DEVELOPMENT APPLICATION ASSESSMENT REPORT

Application Number:	DA2021/1682
----------------------------	-------------

Responsible Officer:	Stephanie Gelder
Land to be developed (Address):	Lot 171 DP 709495, 14 Prince Alfred Parade NEWPORT NSW 2106
Proposed Development:	Alterations and additions to a dwelling house
Zoning:	C4 Environmental Living
Development Permissible:	Yes
Existing Use Rights:	No
Consent Authority:	Northern Beaches Council
Land and Environment Court Action:	No
Owner:	Corri Jane Marshall Stene Marshall
Applicant:	Grant Vallack

Figure 1. Annotated Engineering Plans

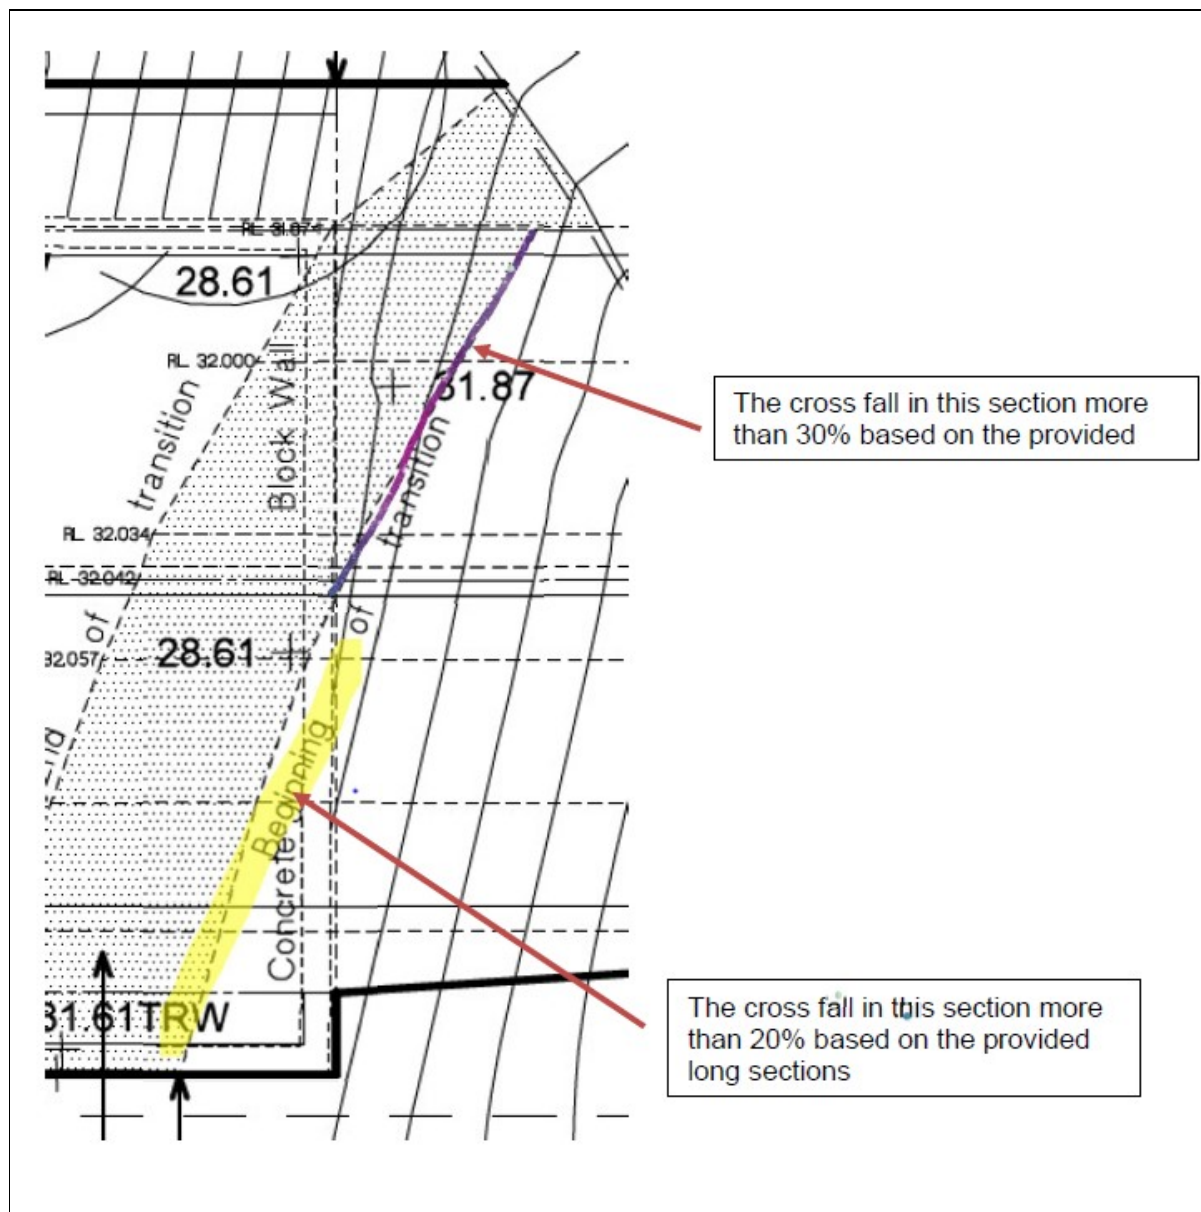
As outlined by Council's Development Engineer, the long sections provided indicates the the crossfall across each wheel path exceeds 20% (see Figure 1). In general the crossfall should not be greater than 10%. The 20% and greater crossfall raises safety concerns when the car is turning into the garage. The proposed application cannot be supported by Development Engineering due to lack of information to address vehicle access for the development. See further discussion from Council's Development Engineer under Internal Referrals in this report.

It is important to note, the applicant has been given three opportunities to provide information to demonstrate compliance with Clause B6.2 Internal Driveways of the Pittwater 21 Development Control Plan. Therefore, in this instance the application is not supportable as the requirements of Clause B6.2 Internal Driveways of Pittwater 21 Development Control Plan have not been demonstrated.

Figure 1. East Elevation

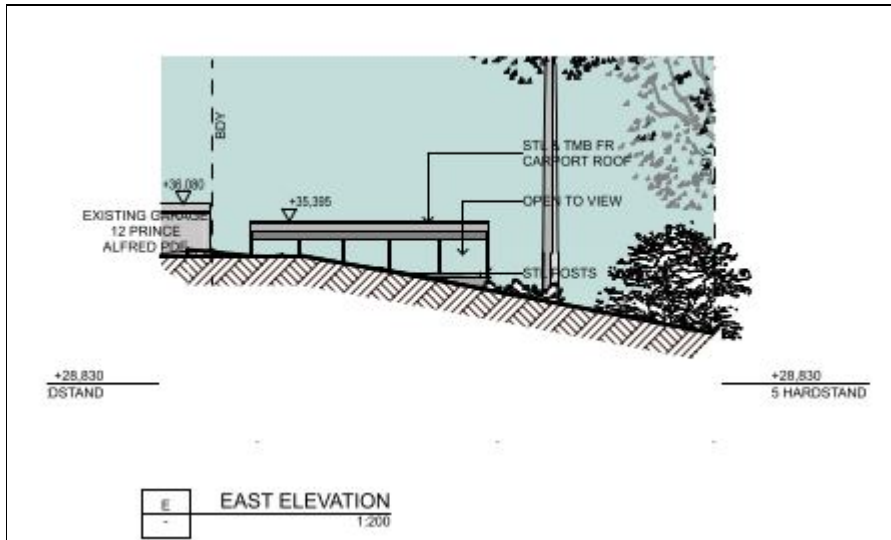
Clause D10.1 of the Pittwater 21 DCP stipulates that parking structures should be located behind the front building line, preferably set back further than the primary building, and be no greater in width than 50% of the lot frontage, or 7.5 metres, whichever is the lesser. The proposed carport is within the front setback area and measures less than half the width of the site (8.9m of 20.18m), however is greater than the prescribed 7.5 metres.

It is important to note that due to the steep topography of the site, the requirement outlined under Clause D10.1 of the Pittwater 21 DCP states that garages, carports and other parking structures including hardstand areas must not be the dominant site feature when viewed from a public place. Due to the steep topography the carport structure is not considered to be dominant when viewed from the streetscape as outlined in Figure 1.

The proximity of the carport to the front boundary line is assessed in this report under Clause D10.7 and a secondary assessment on this clause (which addresses the same objectives) is not required. In summary, the location of the carport is considered to be consistent with Clause D10.1 and is consistent with the character as viewed from a public place.

Figure 2. South Elevation

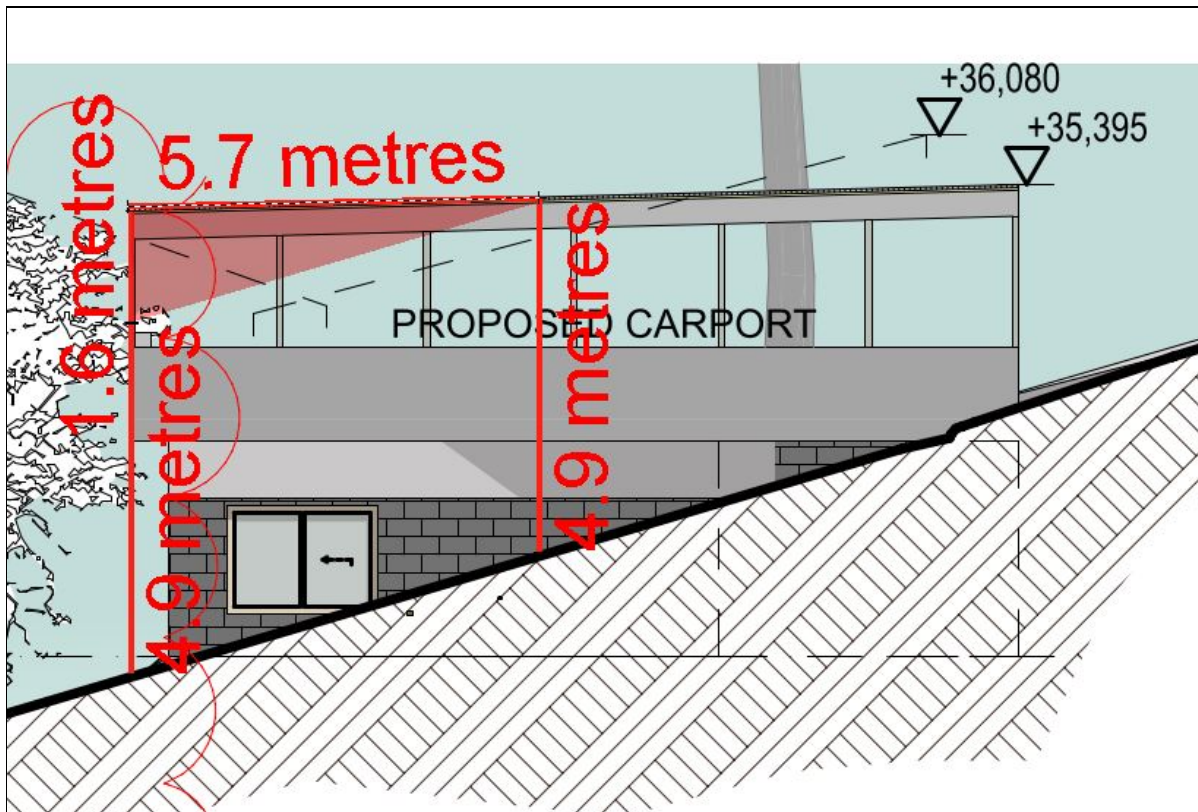
The building envelope on the southern elevation is outside the building envelope (see Figure 2) with a variation of 32.65% (1.6 metres in height over a horizontal length of 5.7 metres).

Under Part D10.11 of Pittwater 21 DCP buildings are to be sited within planes projected at 45 degrees from a height of 3.5m above ground level (existing) at the side boundaries to the maximum building height.

However, as the building footprint has a slope of approximately 30.64% which is greater than 16.7 degrees (30%), variation to this control will be considered on a merits basis.
